Proposal for Supplement 1 to the Regulation on Pole Side Impact in its original version

Proposal for Supplement 1 to the 01 series of amendments to the Regulation on Pole Side Impact

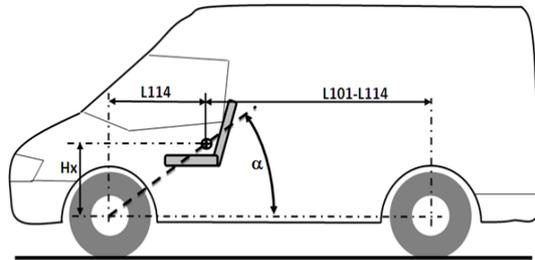
- (a) Category M₁ vehicles **with a gross vehicle mass of up to 3500 kg;** and
- (b) Category N₁ vehicles where the **acute** angle α (α), measured **between a horizontal plane passing through the centre of the front axle and an angular transverse plane passing through the centre of the front axle and the R-point of the driver's seat, as illustrated below**, is less than 22.0 degrees; or the ratio between the distance from the driver's R-point to the centre of the rear axle (L101-L114) and the centre of the front axle and the driver's R-point (L114) is less than 1.30.²

3. Limiting the scope of the **Regulation** to the same maximum masses for commercial vehicles and passenger cars would reduce the burden for those manufacturers producing vehicles of category M1 as a variant of N2, N3, M2, M3 vehicles.
 4. Paragraph 1.1.(b) was slightly amended to further clarify the determination of N1 vehicles in the scope.
-
